Smart Reader HD Technical Bulletin

v01.00.120

Date: 06/17/2020
Subject: New feature, quality of life & stability improvements
Serial # Effective: S0617001
Product Line: Smart Reader HD

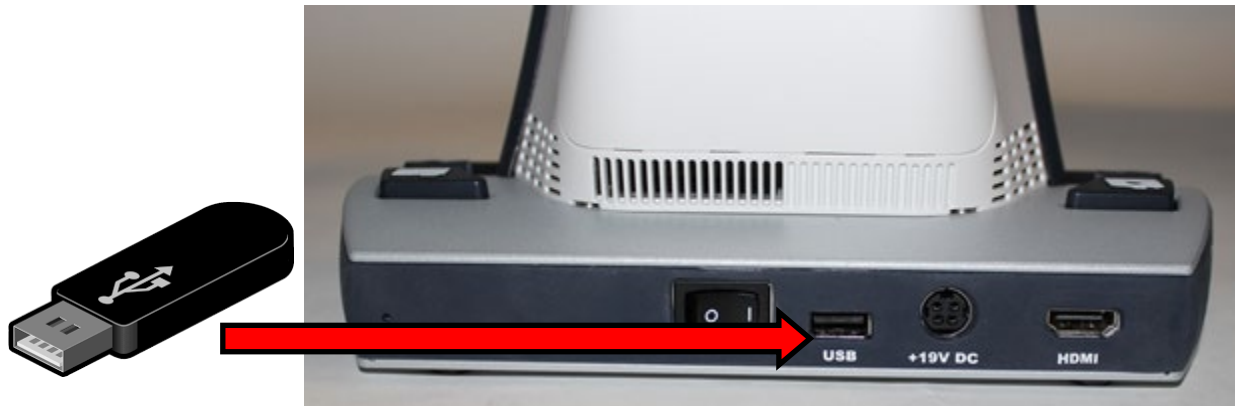
This release addresses many issues that improve the reliability and usability of the Smart Reader HD, including:

- Improved the stability of the device.
- Improved Japanese translations and fixed split-line pronunciations.
- Adjusted OCR speed when pronouncing extra periods in Chinese.
- Added a longer pause at the end of each sentence in French.
- Ensured that the OCR guide frame remains visible.
- Improved OCR camera stability and automatic recovery.
- Updated Smart Reader to automatically enable all audio and sounds when not connected to a display.
